Access Compliance Report

Public Rights-of-Way

(Curb Ramps)

Intersection ID: 11342	Main Street: GEORGIA_AV	Cross Street: MATHESON_AV	Location: E
ADA ID: 2ECFE1A7E839	Ramp Type: Perp	Initial Pass/Fail: Fail	Overall Compliance: No
Codes/Mitigation Info/Possible Solution		Field Measurements/Component Compliance	
Severity Score: 21.25

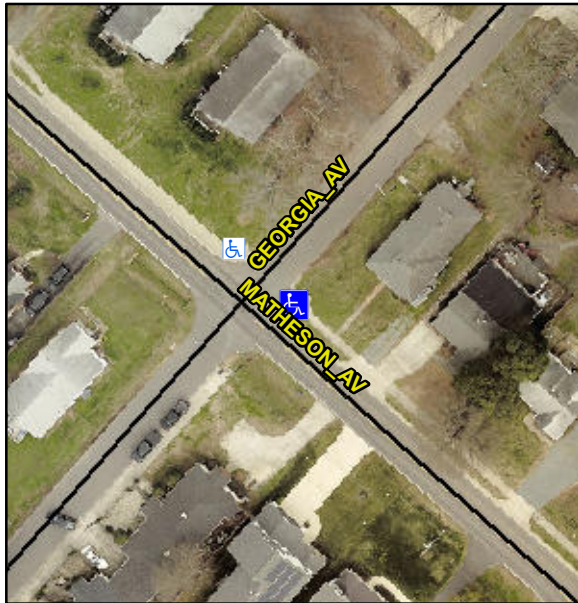
PROW/ADA:

Not Found, R304.5.1, R304.2.2

Compliance	Description	Data	Compliance	Description	Data
N/A	Ramp Length (in)	49.0	No	Ramp Slope (%)	8.7
No	Ramp Width (in)	47.5	Yes	Ramp XSlope (%)	0.3
N/A	Flare Type LT	N/A	N/A	Flare Type RT	N/A
N/A	Flare Slope LT (%)	N/A	N/A	Flare Slope RT (%)	N/A
N/A	Flare Traversable LT?	N/A	N/A	Flare Traversable RT?	N/A
N/A	Landing Length (in)	N/A	N/A	DWS Provided?	N/A
N/A	Landing Width (in)	N/A	N/A	DWS Contrast?	N/A
N/A	Landing Slope (%)	N/A	N/A	DWS Length (in)	N/A
N/A	Landing X Slope (%)	N/A	N/A	DWS Full Width?	N/A
N/A	Landing Curb? (Y/N)	N/A	N/A	DWS Offset (in)	N/A
N/A	Shared Landing?	N/A			
N/A	Gutter Ponding?	N/A	N/A	Gutter Slope (%)	N/A
N/A	Gutter Lip Ht (in)	N/A	N/A	Gutter X Slope (%)	N/A
N/A	Painted X Walk1?	No	N/A	Painted X Walk2?	N/A
	X Walk 1 Direction	To NW		X Walk 2 Direction	N/A
N/A	X Walk 1 Width (in)	N/A	N/A	X Walk 2 Width (in)	N/A
	X Walk 1 Slope (%)	4.9		X Walk 2 Slope (%)	N/A
	X Walk 1 X Slope (%)	2.6		X Walk 2 X Slope (%)	N/A

Possible Solutions:

Remove & Replace Entire Ramp.
